TRI-LAKES MONUMENT FIRE PROTECTION DISTRICT

LOCAL AMENDMENTS
INTERNATIONAL FIRE CODE – 2015
February 26, 2020

FIGURE D103.1 MINIMUM DEAD-END FIRE APPARATUS ACCESS ROAD TURNAROUND.

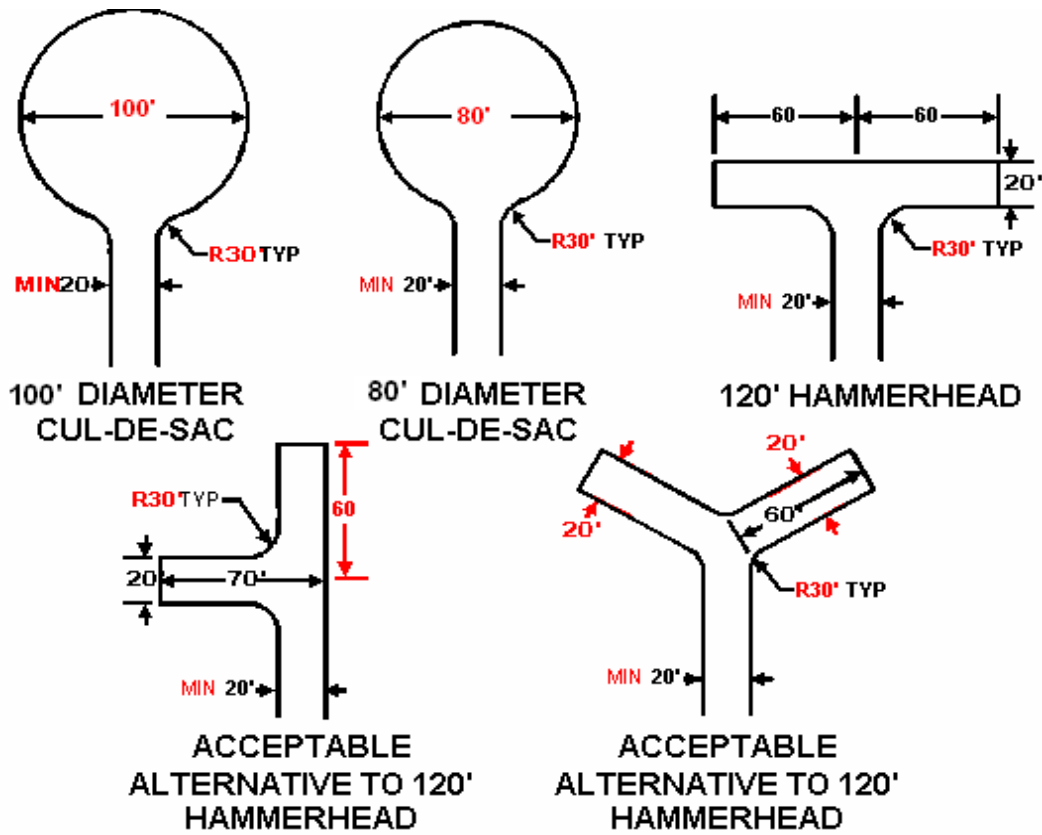
Figure D103.1. Dead-End Fire Apparatus Access Road Turnaround. Delete Figure D103.1 and replace with the following:
